TE Connectivity

Product Change Notification: PCN-26-282911

STANDARD POWER TIMER CONTACT

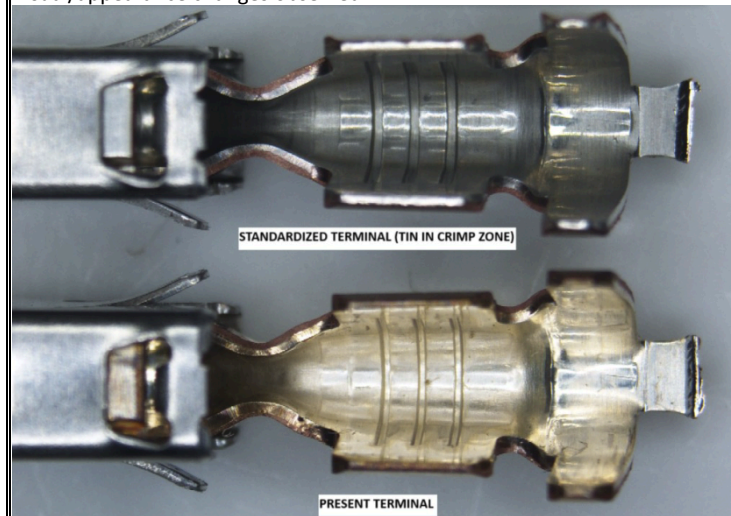
Dear Customer, Tin (Sn) plating has been introduced in Crimp zone area for below Part Numbers to standardize crimp zone of Standard Power Timer Contact System. There might be changes in visual appearances in the crimp area of the part as shown below. The visual difference in the crimp area has no impact on the function, reliability, or processing of the product. Internal process and quality is ensured by TE.

Visual/appearance changes observed.
